**MARION COUNTY COMMISSION
MARION COUNTY, WEST VIRGINIA**

PALATINE PARK IMPROVEMENTS

ADDENDUM #1

THRASHER PROJECT #030-10387

SHEET No.
C002

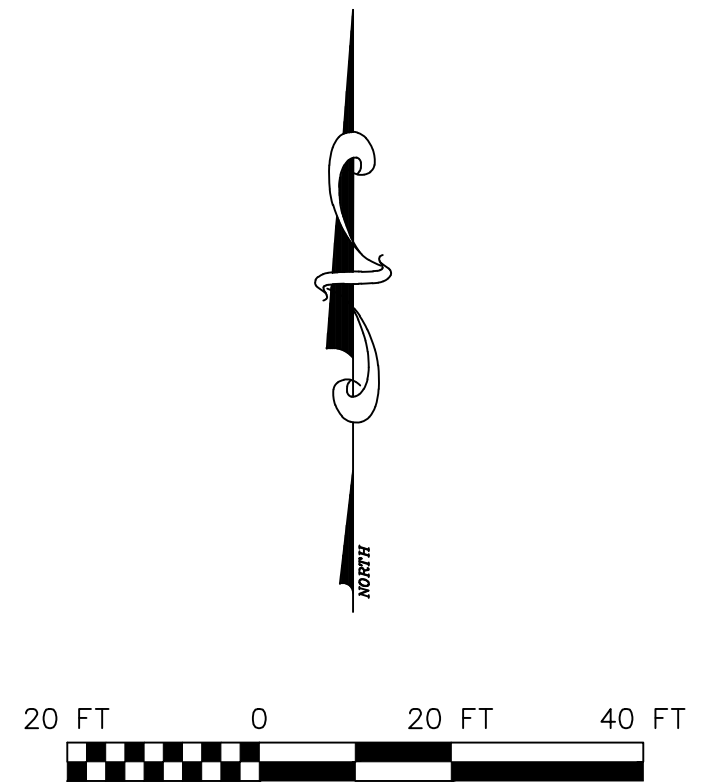
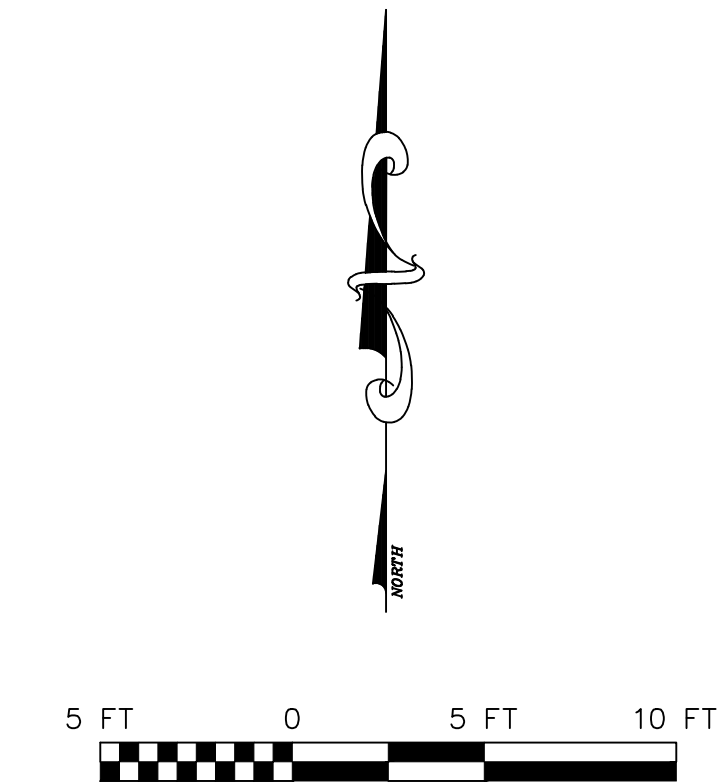
1. There is a note on C002 – “All existing light fixtures shall be upgraded/replaced with a high lumen output option” Is this part of the scope of work? If so, how many lights and can you get us a spec on these?

NO.	BY	DATE	DESCRIPTION
1	RJH	3/17/22	REMOVED NOTE ABOUT PARK LIGHTS, IDENTIFIED LOCATION OF SOIL WASTE

This note has been removed. There is no intended work on the existing park lights as part of this contract.

SHEET No.
C001

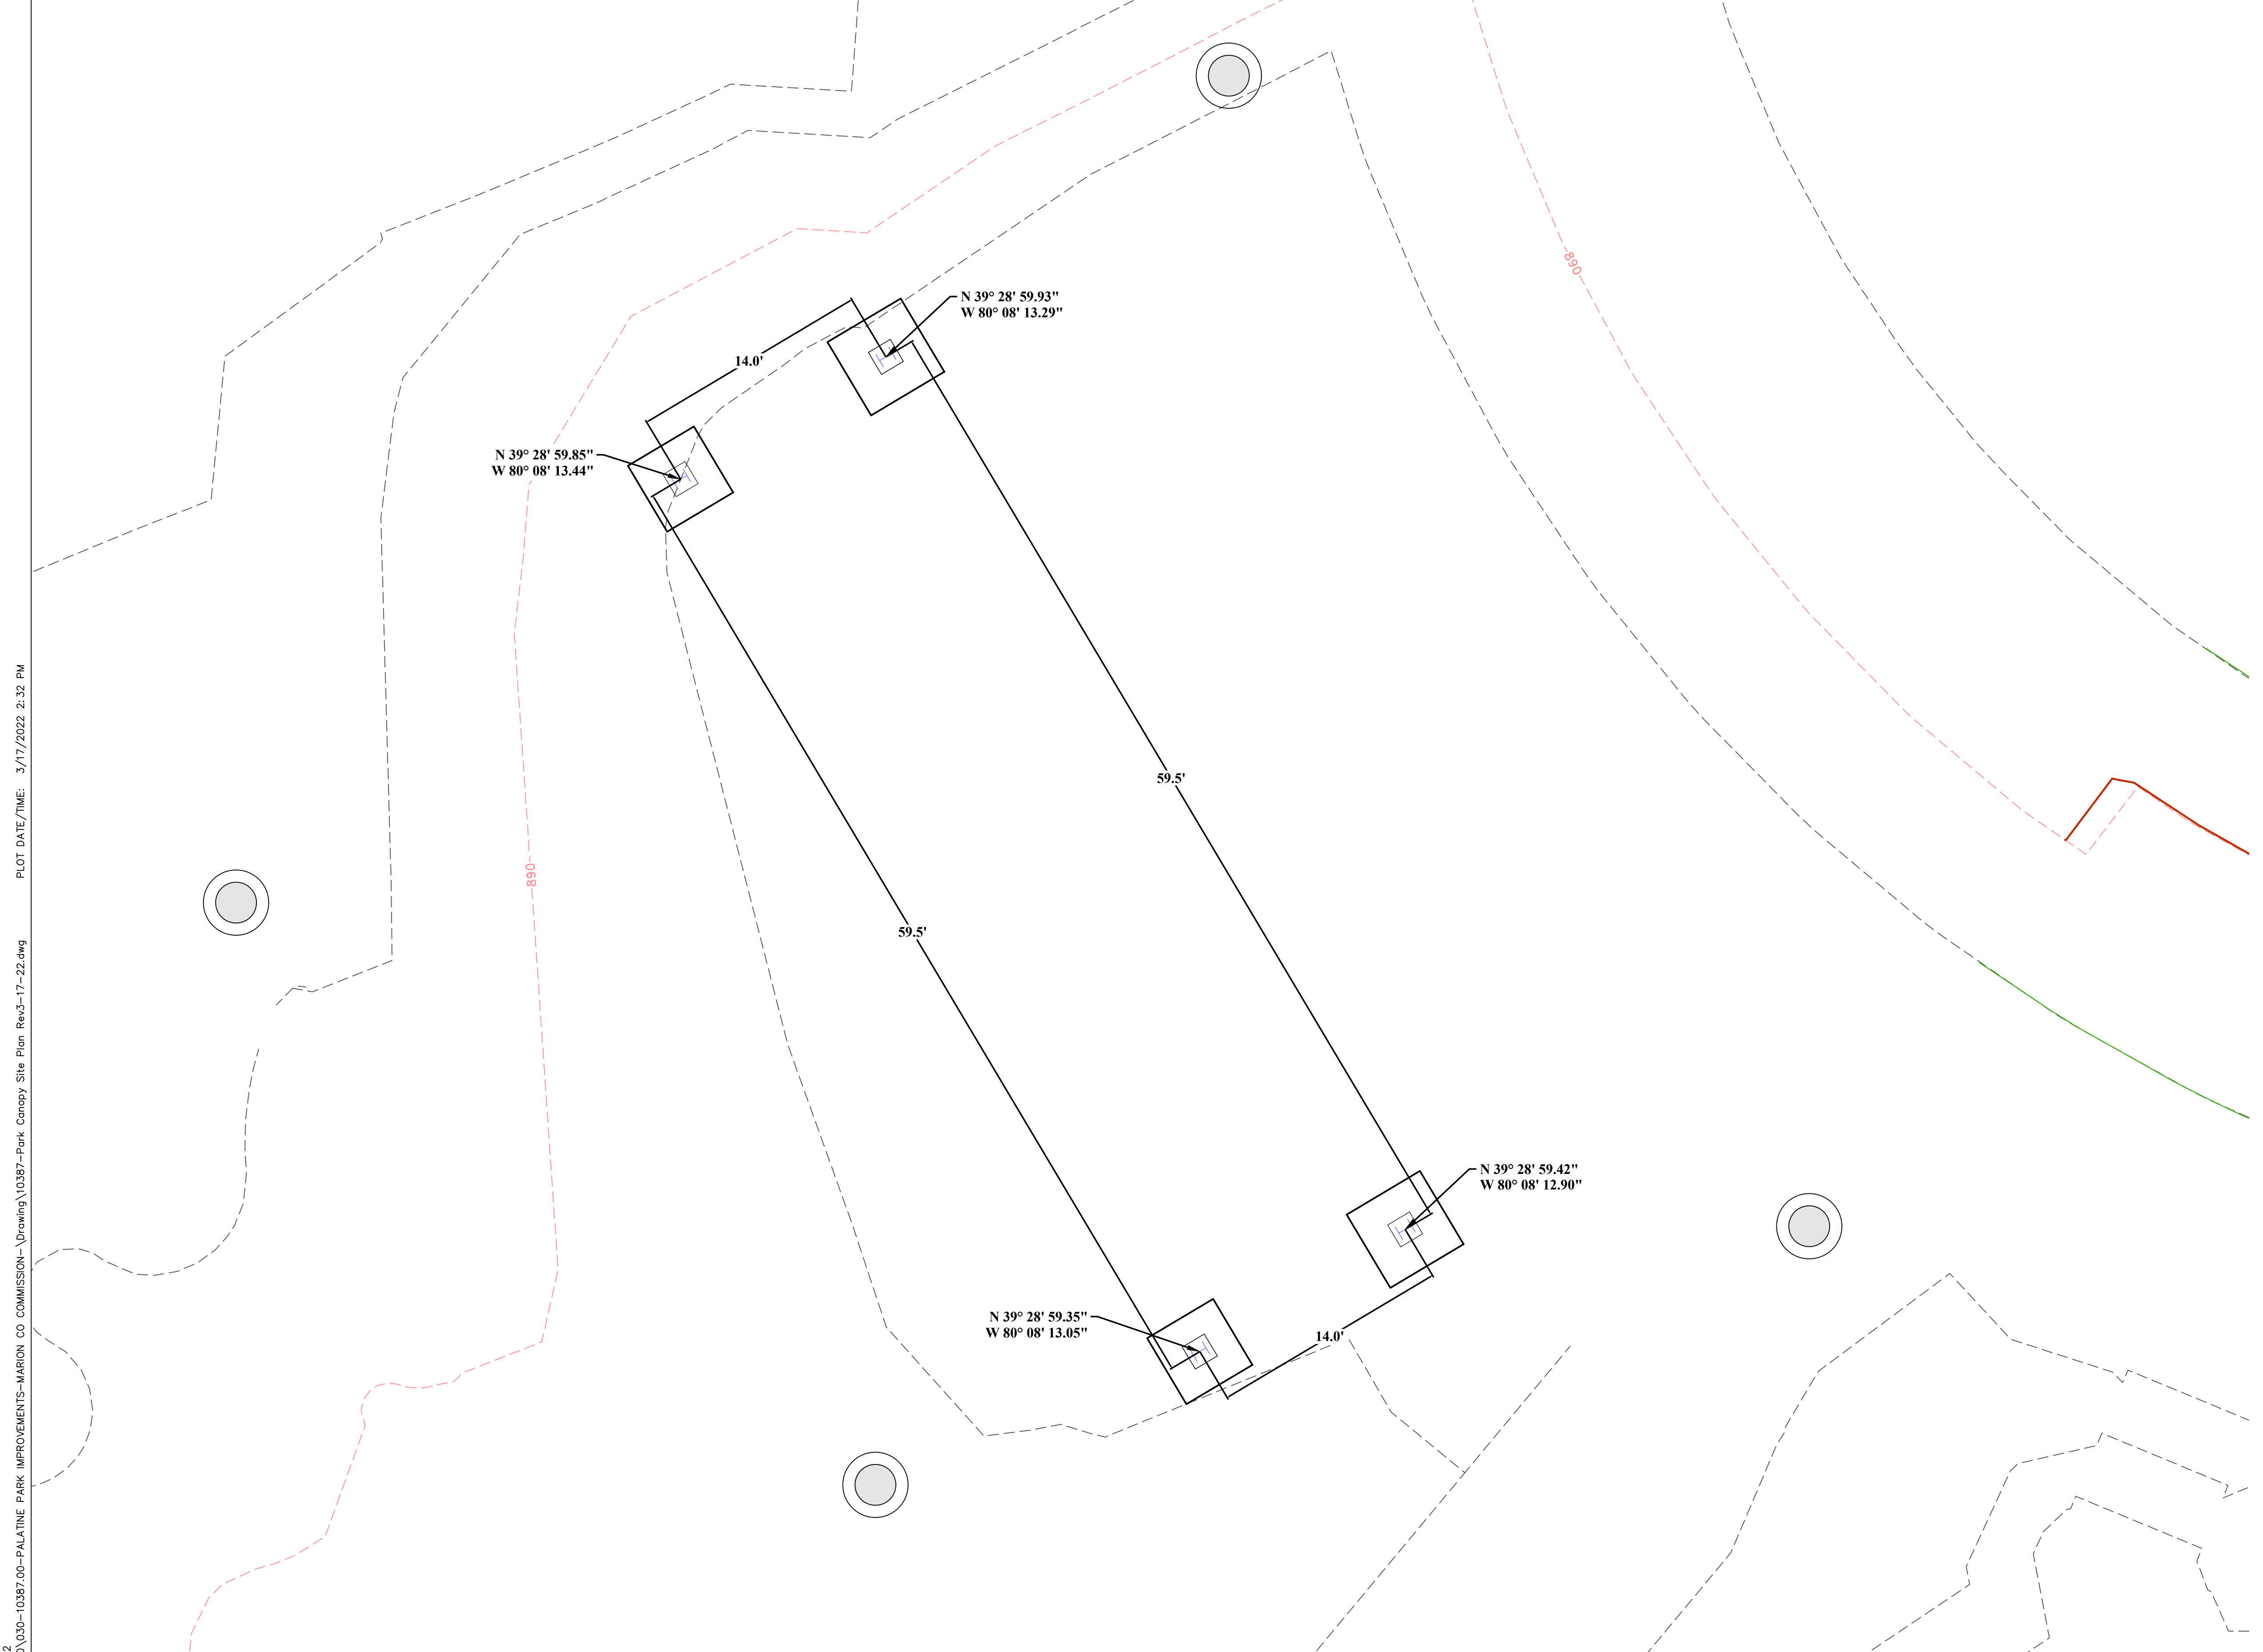
NO.	BY	DATE	DESCRIPTION
1	R/JH	3/17/22	REMOVED NOTE ABOUT PARK LIGHTS, IDENTIFIED LOCATION OF SOIL WASTE

The foundation spoil can be wasted in the area between the parking lot and the river. Material will need to be spread and graded to provide positive drainage and will need to be seeded.
